Access Compliance Report

Public Rights-of-Way

(Curb Ramps)

| Intersection ID: 23951 | Main Street: S_TRYON_ST | Cross Street: CHOATE_CR | Location: SW |

| ADA ID: F3EB94FA19CE | Ramp Type: PerpDiag | Initial Pass/Fail: Fail | Overall Compliance: No |

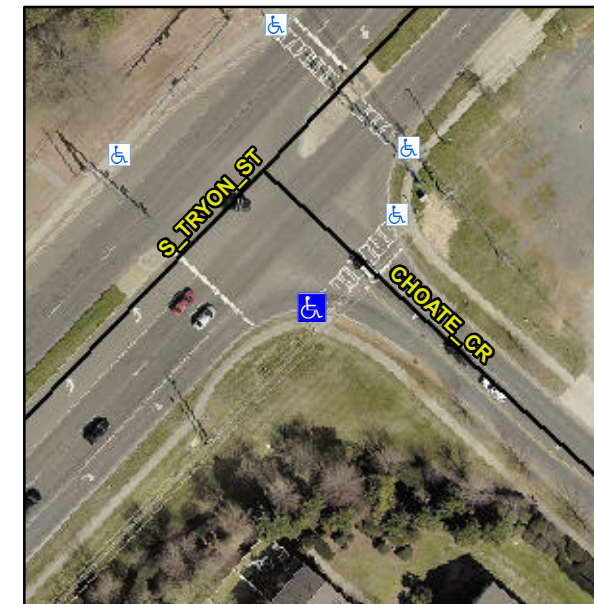
Not Found, R304.5.1

| Compliance | Description | Data | Compliance | Description | Data |
|------------|-----------------------|-------|------------|-----------------------------|-------|
| No | Ramp Width (in) | 47.0 | Yes | Ramp XSlope (%) | 3.4 |

Remove & Replace Curb Ramp With Two New Directional Ramps or Equivalent.
